Town of Hilton Head Island Regular Design Review Board Meeting

February 26, 2019 – 1:15 p.m. Benjamin M. Racusin Council Chambers AGENDA

FERN IAMS AMISH STYLE RESTAURANT

PROJECT NAME: Fern Iams Amish Style	Restaurant		DRB#: DRI	3-000289-2019
DATE: February 14, 2019				
RECOMMENDATION: Approval				
APPLICATION MATERIAL				
DRB REQUIREMENTS	Complies Yes	No	Not Applicable	Comments or Conditions
Detail Illustrating Connection to Existing Structure				The buildings are connected in a way that results in irregular angles in the roofline.
ARCHITECTURAL DESIGN				
ARCHITECTURAL DESIGN DESIGN GUIDE/LMO CRITERIA	Complies Yes	No	Not Applicable	Comments or Conditions
	_	No 🖂	Not Applicable	The structure does not relate to the surrounding buildings in color or form.
DESIGN GUIDE/LMO CRITERIA Structure is designed to be appropriate to the	Yes		Not Applicable	The structure does not relate to the surrounding buildings in color or form. There is no pathway connection associated with the door on the west side of the building. The existing and proposed walkways are not 5' wide.
DESIGN GUIDE/LMO CRITERIA Structure is designed to be appropriate to the neighborhood	Yes			The structure does not relate

PERMIT SET A-2

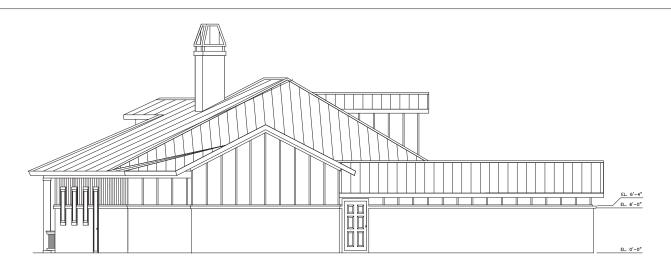
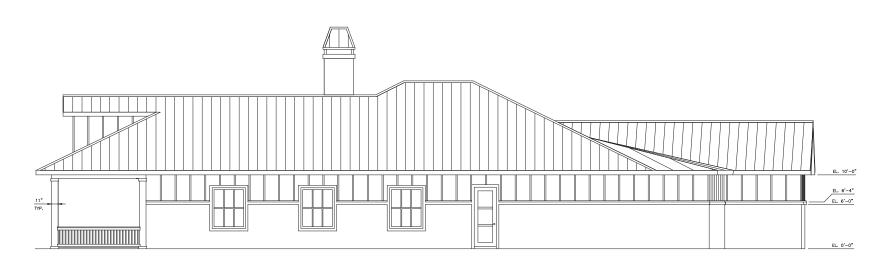
DESIGN GUIDE/LMO CRITERIA Structure is designed to be appropriate to the neighborhood Promotes pedestrian scale and circulation Design is unobtrusive and set into the natural	Yes			The structure does not relate to the surrounding buildings in color or form. There is no pathway connection associated with the door on the west side of the building. The existing and proposed walkways are not 5' wide. The design simply maximizes the building area and does not relate to the existing walkways. The colors

residential look rather than commercial. These features do not relate to the architecture of the surrounding buildings.
Avoids monotonous planes or unrelieved repetition		\boxtimes		The addition is not appropriately scaled for the site.
Has a strong roof form with enough variety to provide visual interest				Roof design needs to be simplified.
Utilizes a variety of materials, textures and colors				Colors are high contrast.
Details are clean, simple and appropriate while avoiding excessive ornamentation		\boxtimes		Roof design needs to be simplified.
Utilities and equipment are concealed from view				Utility screening is not provided. A slop sink is shown outside of the rear of the building with no screening.
Decorative lighting is limited and low wattage and adds to the visual character		\boxtimes		No lighting fixtures are shown on the plans for the building or site.
Accessory elements are designed to coordinate with the primary structure		\boxtimes		The proposed addition to the existing building is irregular and results in odd roof angles.

Sheet #: LS-1.0

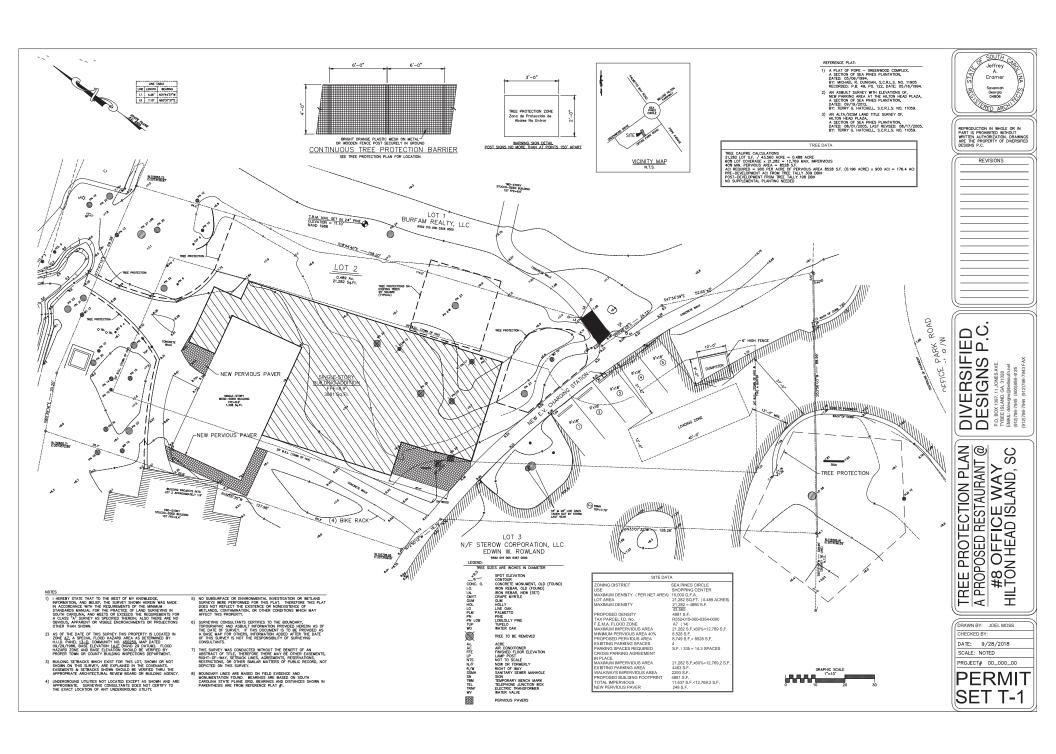
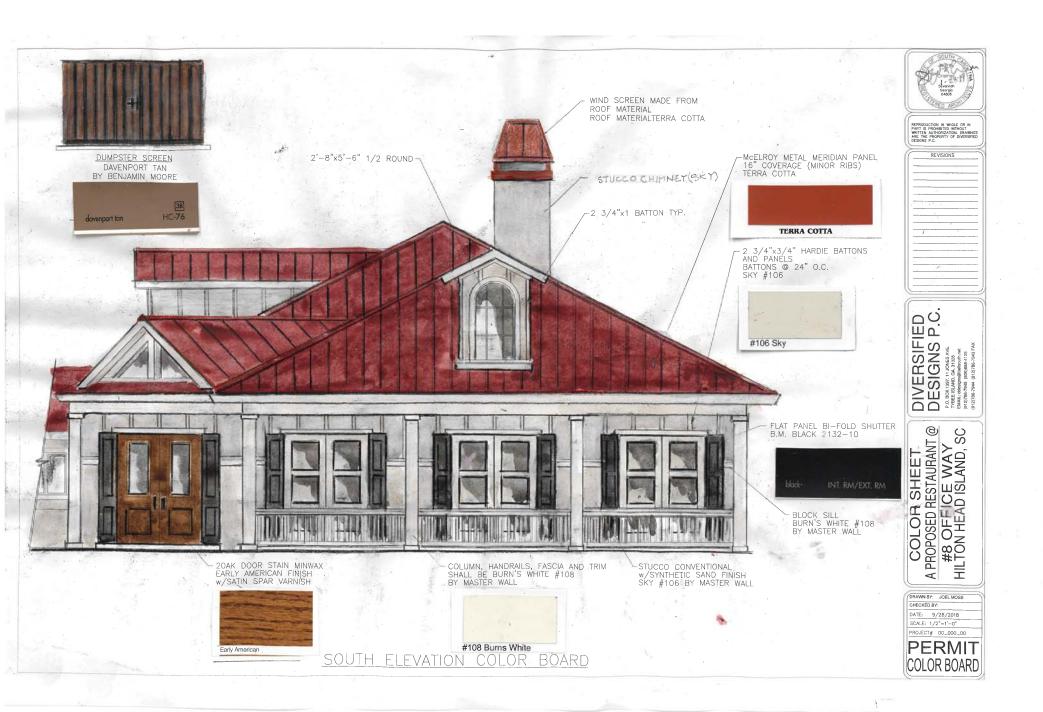
LANDSCAPE DESIGN				
DESIGN GUIDE/LMO CRITERIA	Complies Yes	No	Not Applicable	Comments or Conditions
			MotApplicable	
Treats the Landscape as a major element of the project				
Provides Landscaping of a scope and size that is in proportion to the scale of the development				The number of proposed plants and the distribution of plants are not sufficient for the scale of the building.
Provides Landscaping of a scope and size that is in proportion to the scale of the development Preserves a variety of existing native trees and shrubs				
Provides Landscaping of a scope and size that is in proportion to the scale of the development Preserves a variety of existing native trees and shrubs Provides for a harmonious setting for the site's structures, parking areas or other construction				
Provides Landscaping of a scope and size that is in proportion to the scale of the development Preserves a variety of existing native trees and shrubs Provides for a harmonious setting for the site's structures, parking areas or other construction Location of existing trees and new trees provides street buffers, mitigation for parking lots, and an architectural complement that visually mitigates between parking lots and building(s)

Provides Landscaping of a scope and size that is in proportion to the scale of the development Preserves a variety of existing native trees and shrubs Provides for a harmonious setting for the site's structures, parking areas or other construction Location of existing trees and new trees provides street buffers, mitigation for parking lots, and an architectural complement that visually mitigates between parking lots and building(s) Shrubs are selected to complement the natural setting, provide visual interest and screen less desirable elements of the project				There should be room between the building and walkway for a plant bed. Bottle Brush and Sweet Viburnum are not native. The balance of the planting seems foreign to this area.
Provides Landscaping of a scope and size that is in proportion to the scale of the development Preserves a variety of existing native trees and shrubs Provides for a harmonious setting for the site's structures, parking areas or other construction Location of existing trees and new trees provides street buffers, mitigation for parking lots, and an architectural complement that visually mitigates between parking lots and building(s) Shrubs are selected to complement the natural setting, provide visual interest and screen less desirable				There should be room between the building and walkway for a plant bed. Bottle Brush and Sweet Viburnum are not native. The

Summer House Exterior Paint Review

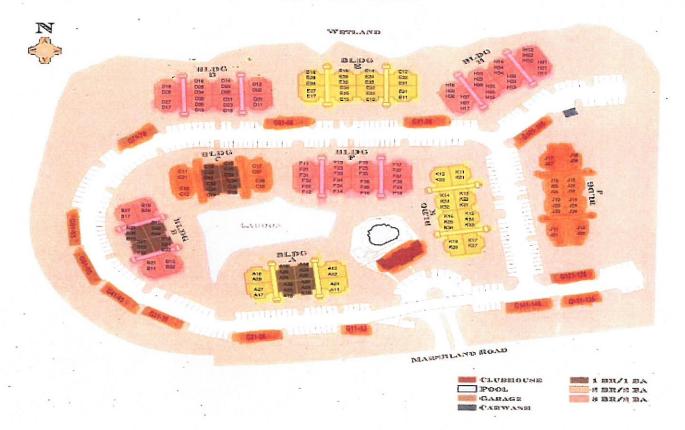
Regarding specific colors presented, staff recommends SW 2822, Downing Sand, SW 7518, Beach House, and SW 6163 Grassland per the Design Guide page 16, "Colors shall not be used to cause the structure to stand out from others or its background."
